SERVICE BULLETIN

APPLICABILITY: 2012-17MY Legacy and Outback
 2014-16MY Impreza
 2014-17 Crosstrek
 2012-17MY Forester
 2014-17MY WRX and WRX STI

NUMBER: 07-152-19

SUBJECT: Power Window Switch Changes

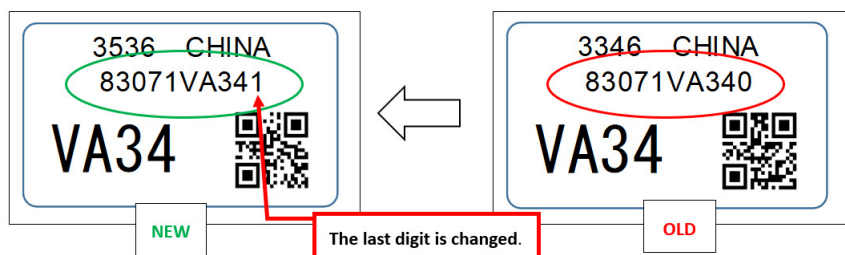
Use the part number on the label to distinguish between the old and new switches as shown below:
